**ADDENDUM TO APPLICATION**  
**BLOCK 136, LOT 8 (30 GRANT AVENUE)**  
**MARKOV APPLICATION**  
**BOROUGH OF RUMSON**

## Denial Memorandum

Applicant: June Markov  
Address: 30 Grant Avenue                      Block                      Lot                      Zone  
Rumson, NJ 07760                      136                      8                      R-5

## Memorandum

SP-1.00

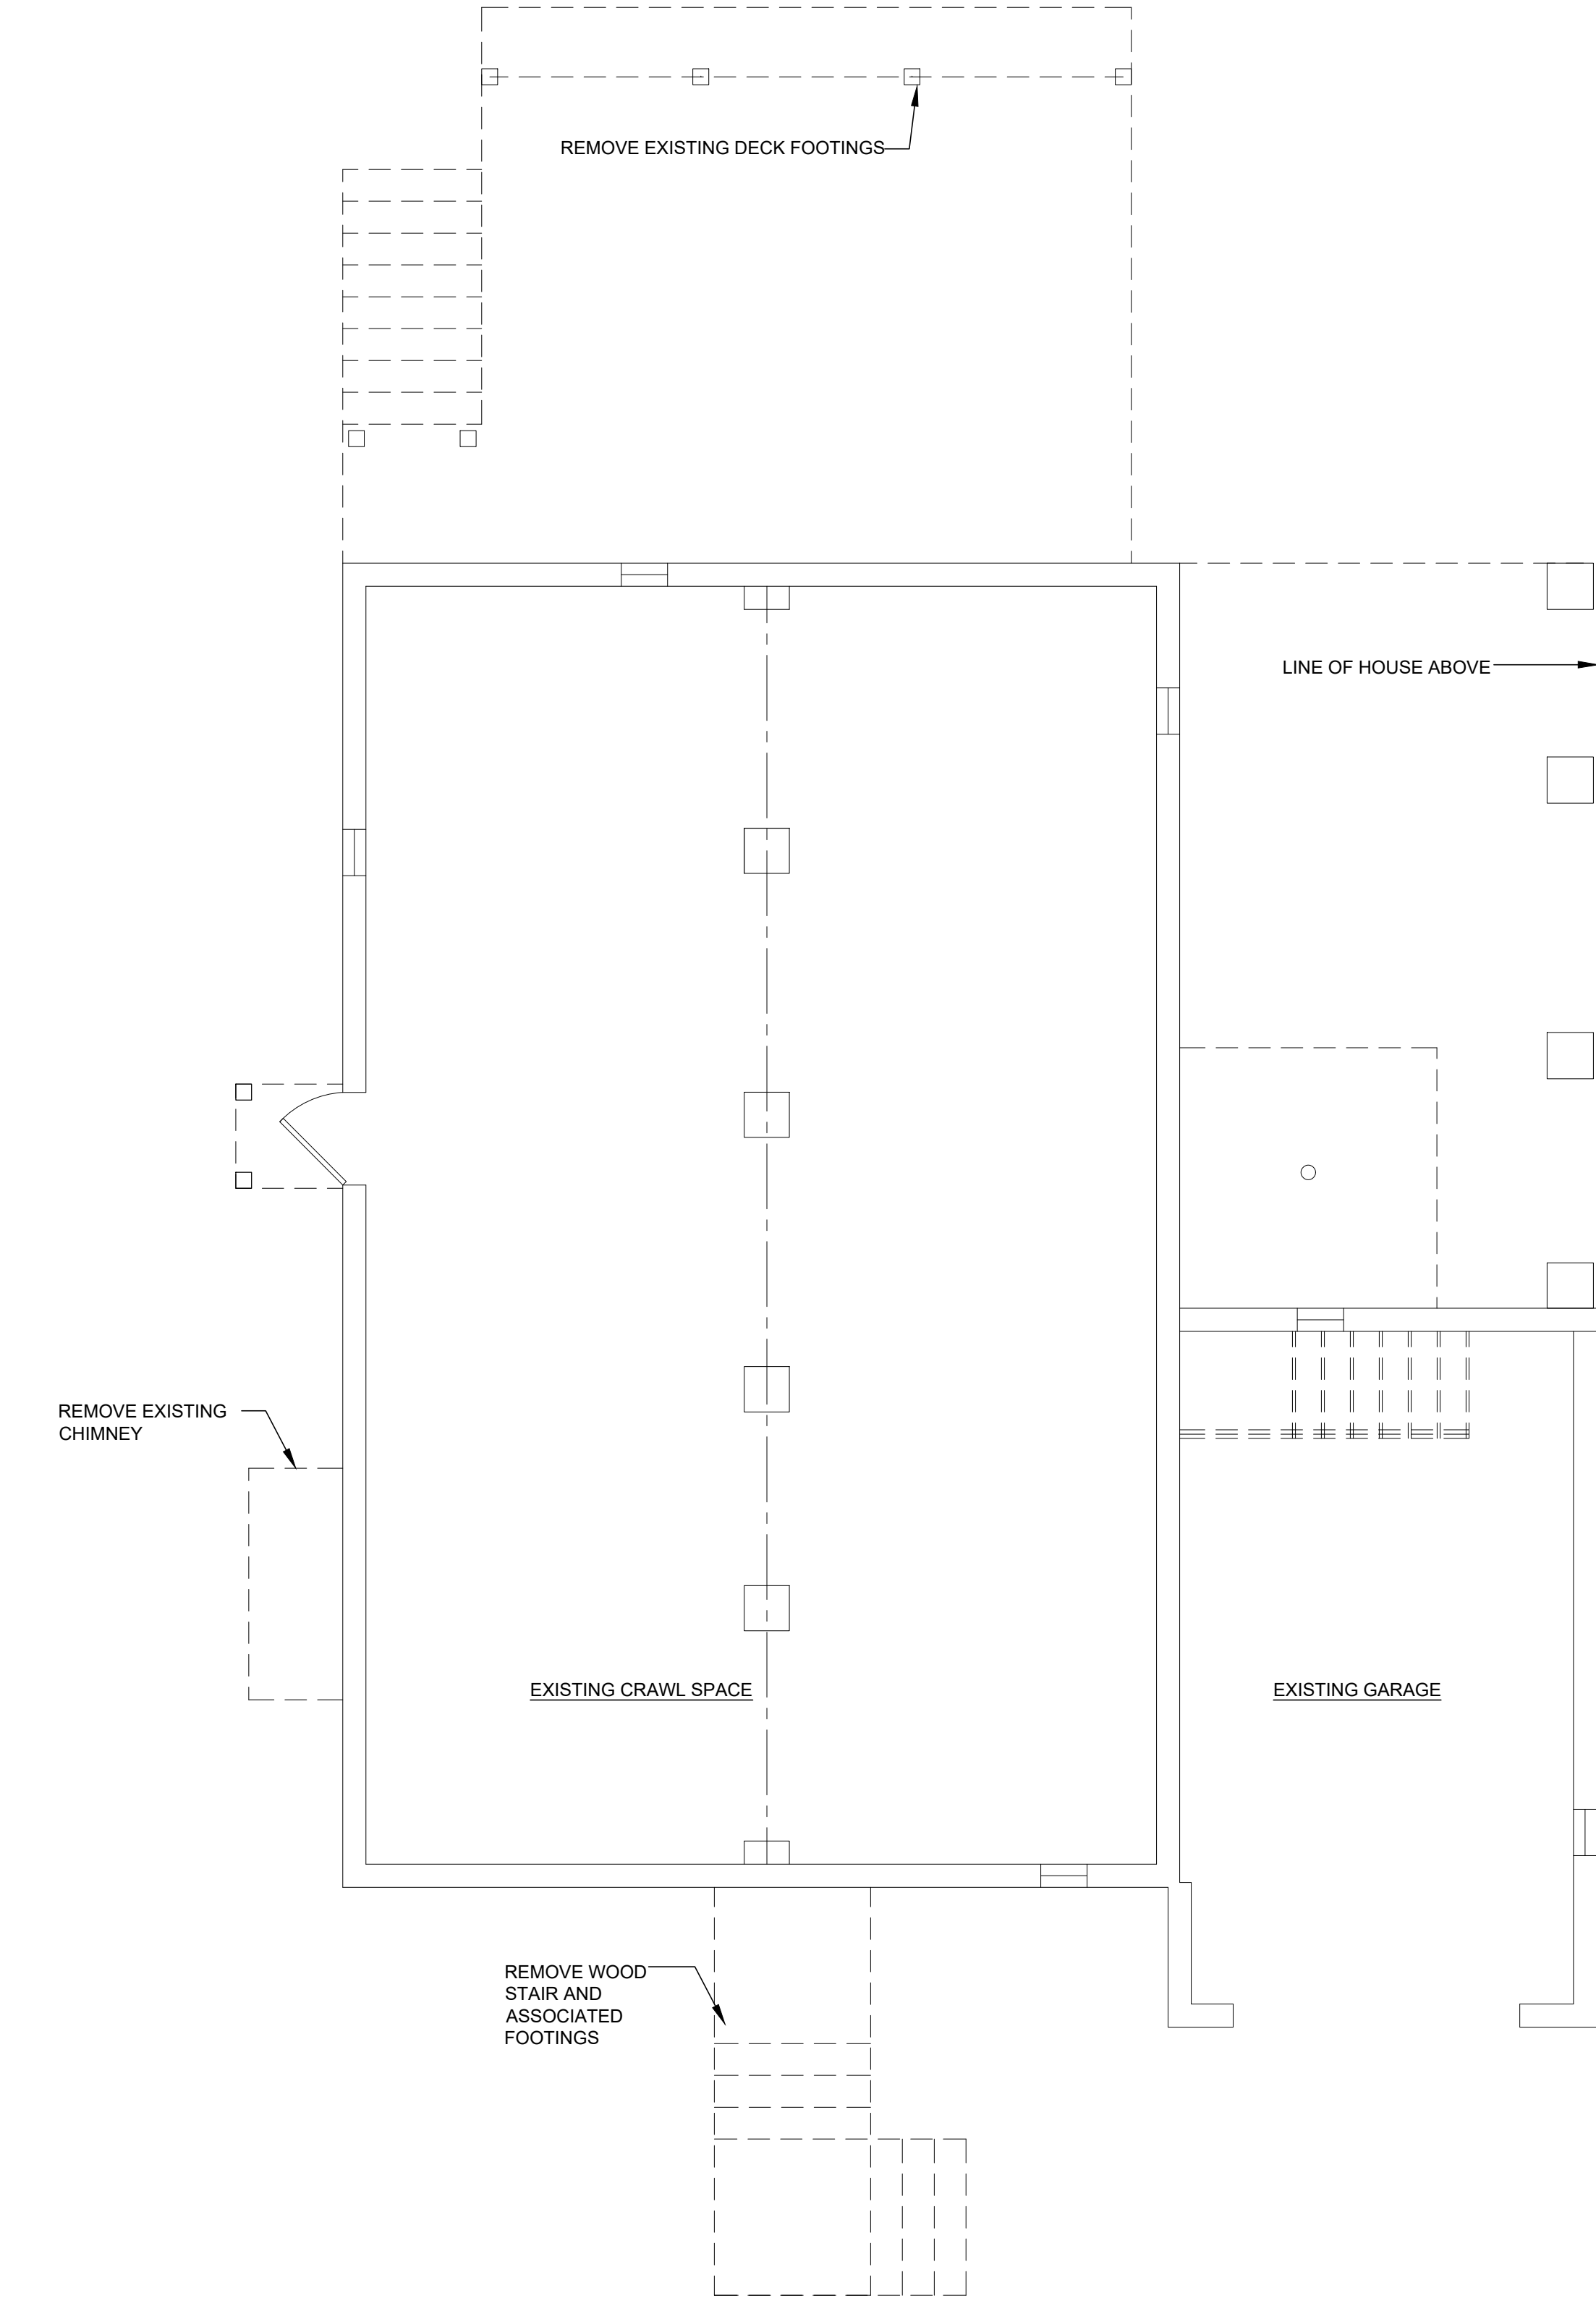
10. Zoning Chart Information requiring correction:
  - To comply with half-story status, please provide the proposed area that is greater than 5' above the second floor. This cannot be greater than 60% of the floor area below it. (Half story status is <60% of the floor below it, habitable attic is <1/3 of the floor below it).

- Note 5: as shown, the proposed rear yard setback is 39'-2.5". Please correct in Zoning Chart
